Recommending a half grant towards the construction of an upper storey over the northern wing of the Lawley Hall attached to St. Joseph's College, Trichinopoly.

The Director of Public Instruction submits for sanction, through the Educational Department, plans and estimate amounting to Rs. 25066 for an upper storey over the northern wing of the Lawley Hall of St. Joseph's College, Trichinopoly.

Grant for the construction of an upper story over the northern wing of the Lawley Hall attached to the St. Joseph's College, Trichinopoly.

PLAN
OF
THE NORTH WING OF THE LAWLEY
TO BE CONVERTED INTO AN UPPER STORY ST JOSEPH'S COLLEGE
AT
TRICHINOPOLY
SCALE 1/8" = 1' - 0"

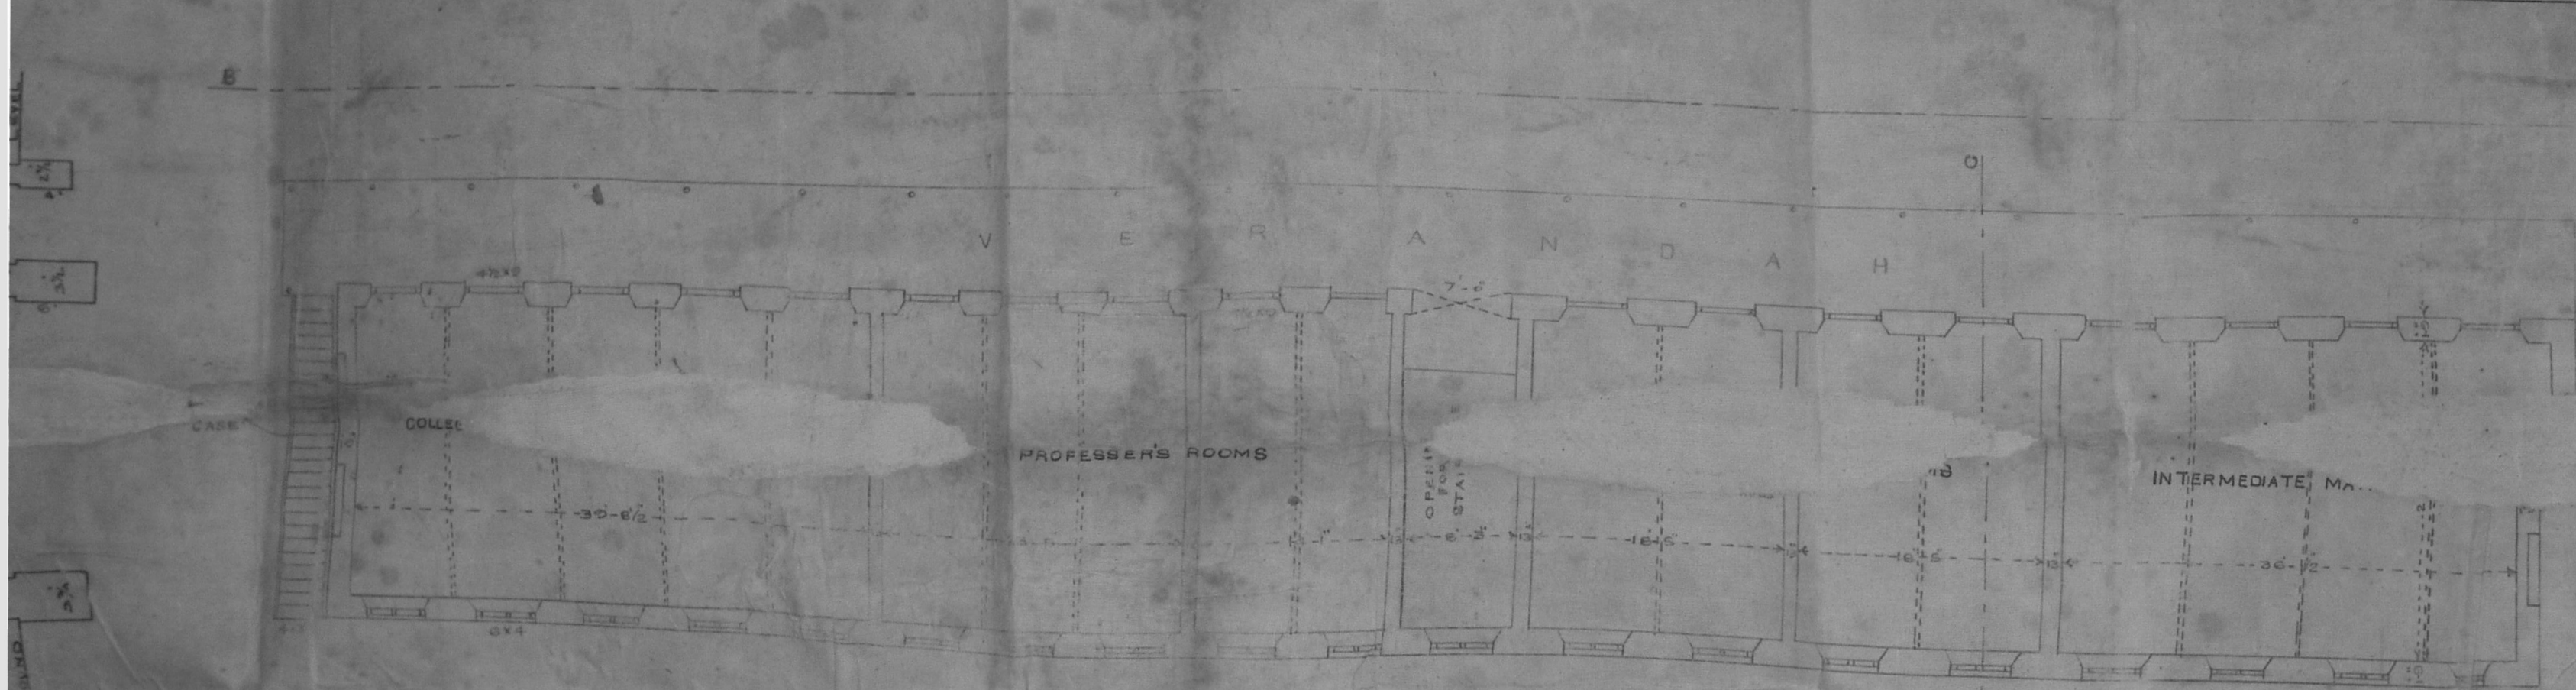
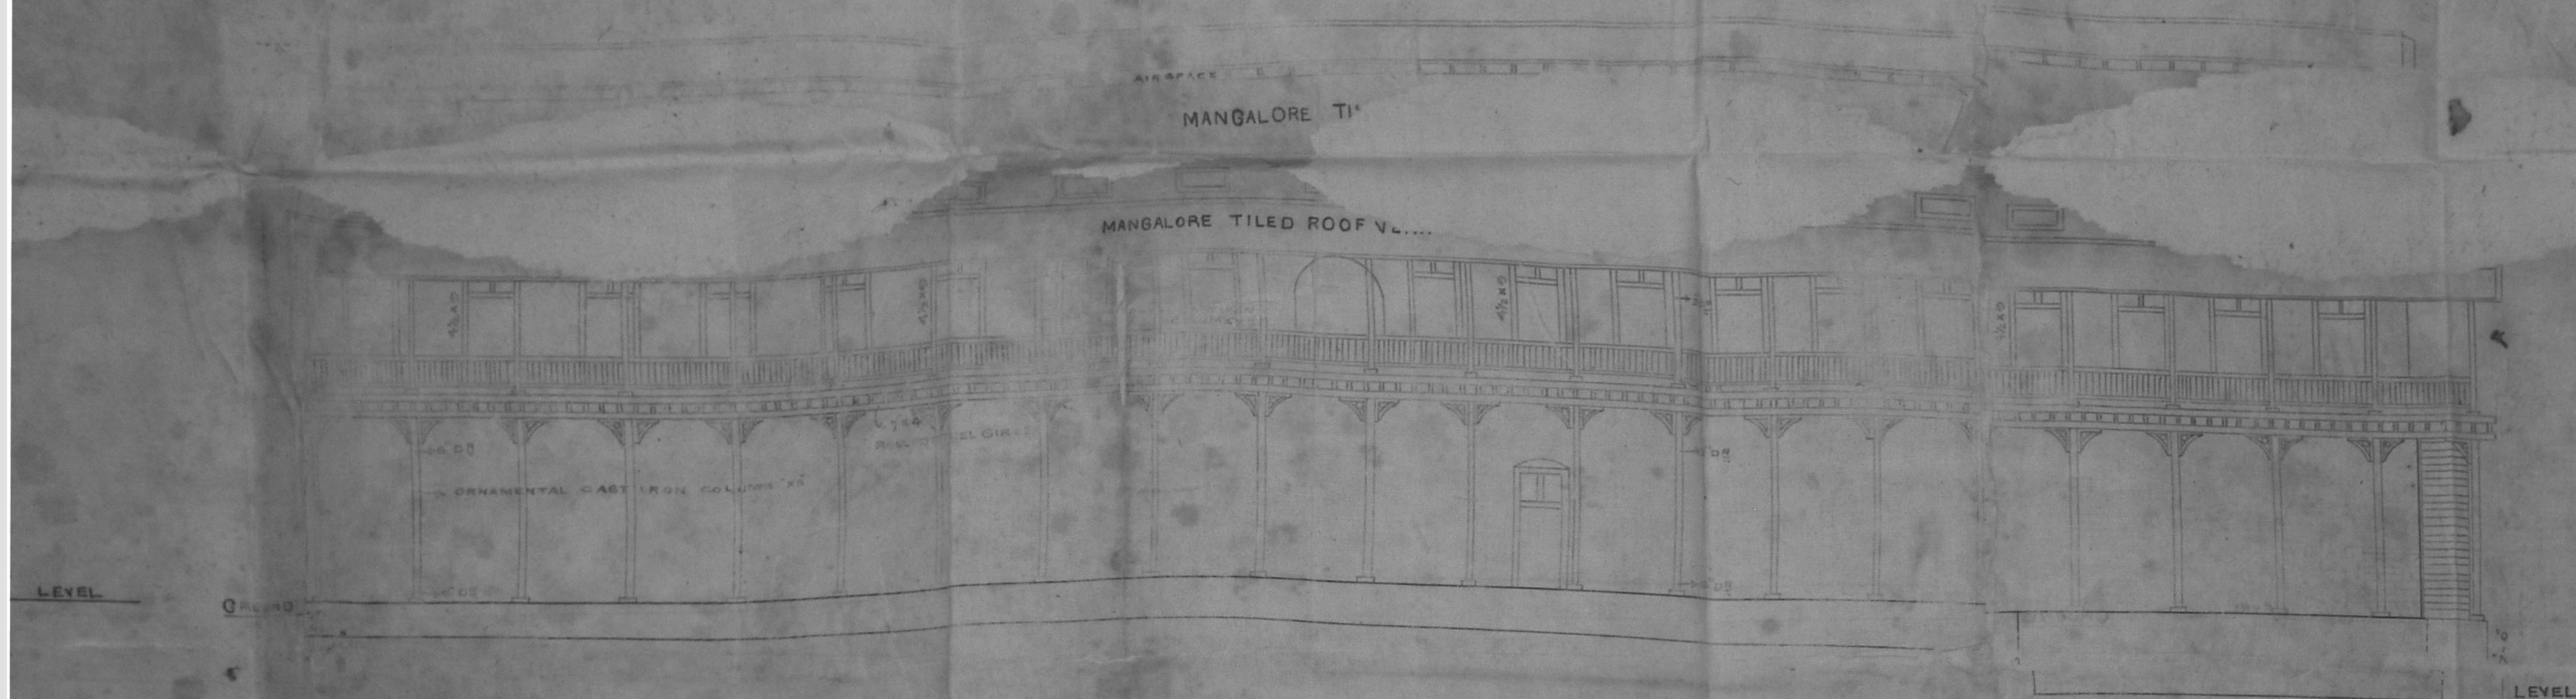
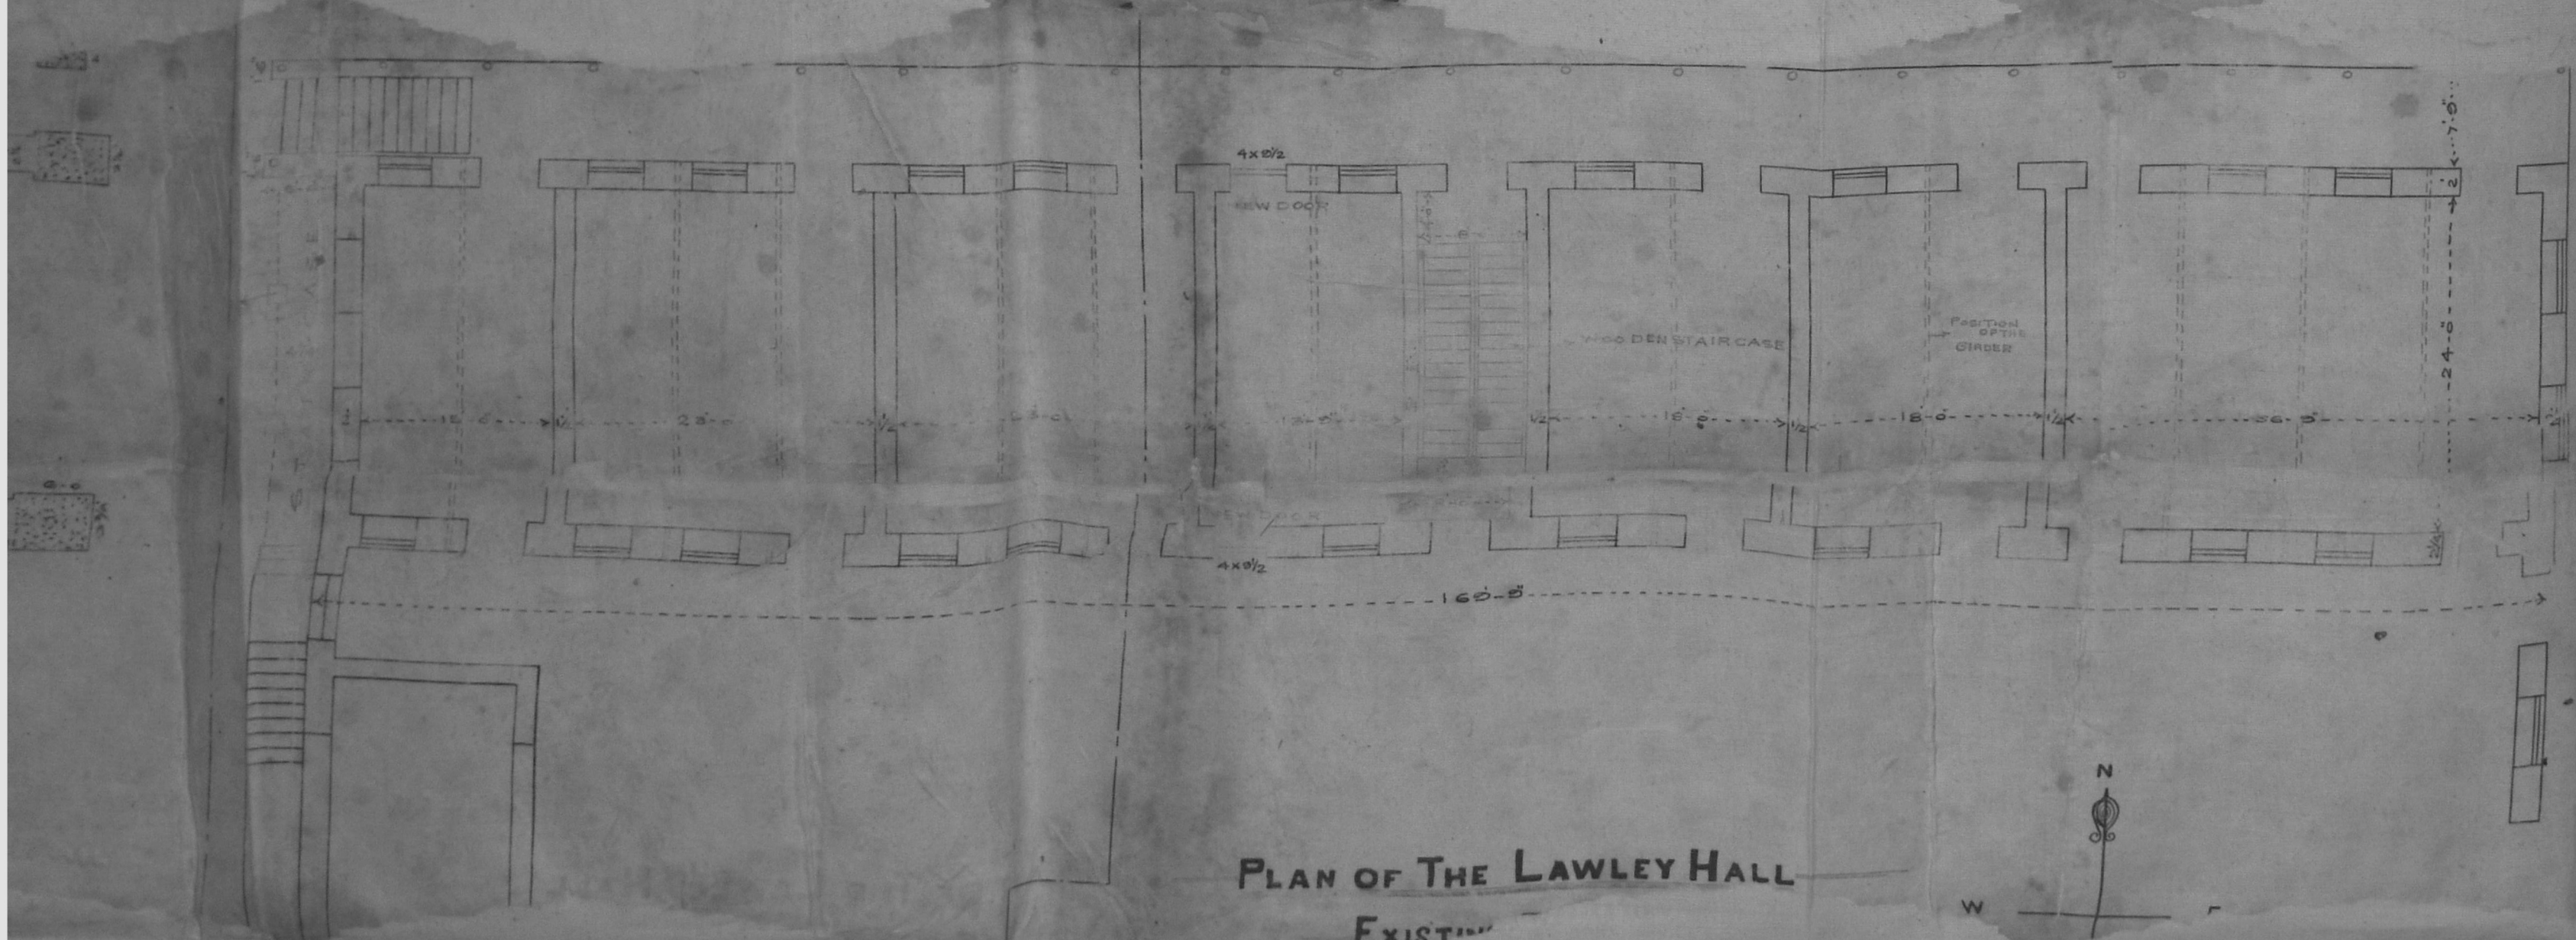
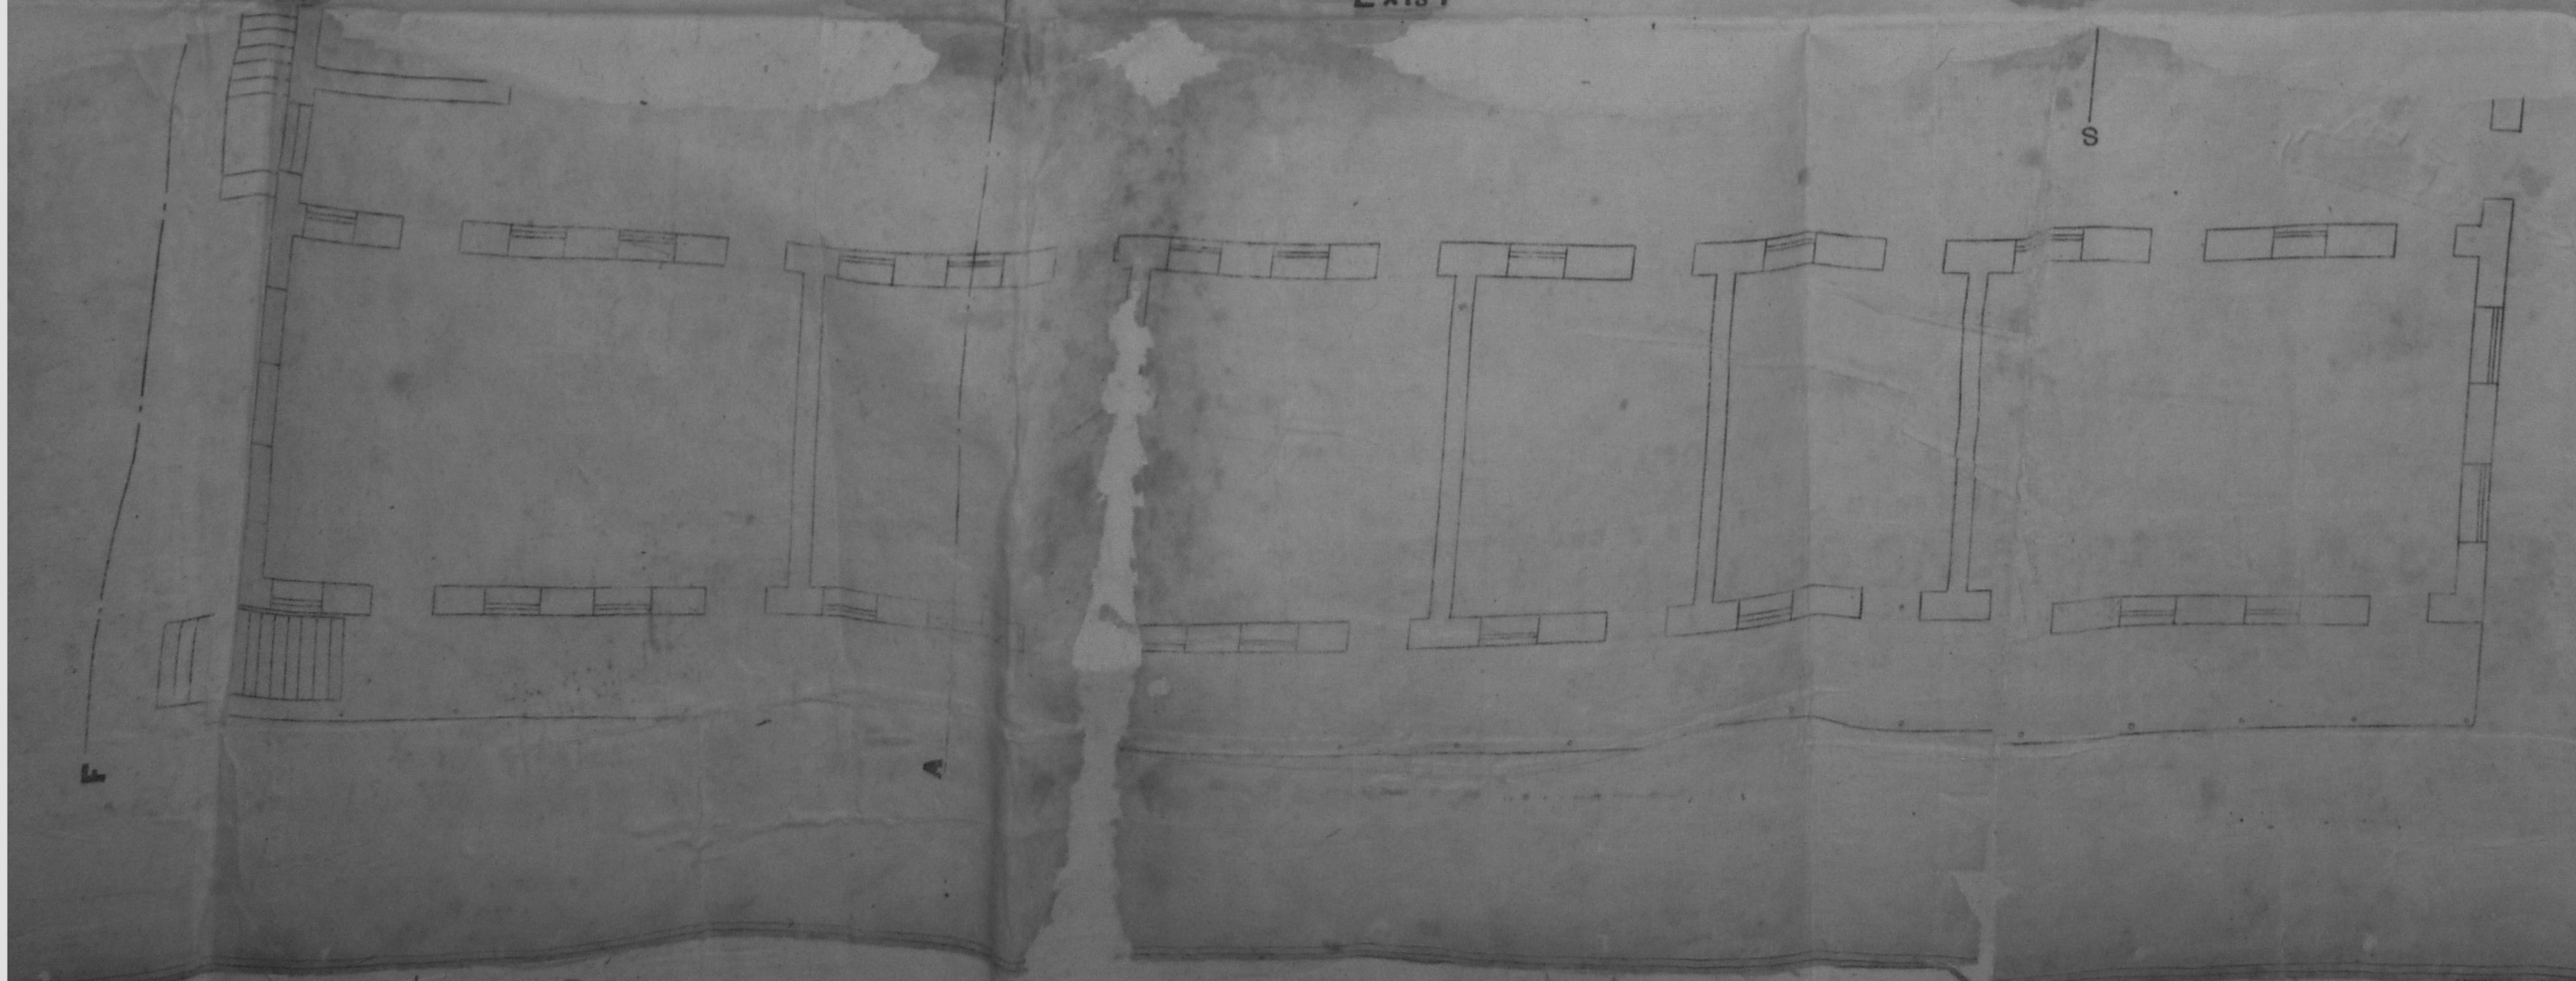
A. The sizes of the doors and windows of the existing north wing and the positions of the truss in the Central hall are not marked on the plans.

B. The nature of the existing roofs should be described, whether Mangalore tiles over flat tiles with air spaces, Mangalore tiles imbedded in 1" mx mortar or plain Mangalore tiles.

C. The scantlings of the existing roof timbers should be marked on the plans with their spacing centre to centre.

D. There is no need of one additional truss as those removed from the existing roof are sufficient for the proposed first floor.

E. The thickness of the walls on the proposed first floor are marked 13 inches ^{on the plan} but the estimate shows 18 inches.

F. The weights per foot of Cast iron columns for 5½" ^{average} and 3½" diameters are given as 45.31 lbs. against an approximate weight of 34.95 and 20.22 lbs. per foot respectively.

With these remarks the plans and
estimates are returned for resubmission
with the required informations.
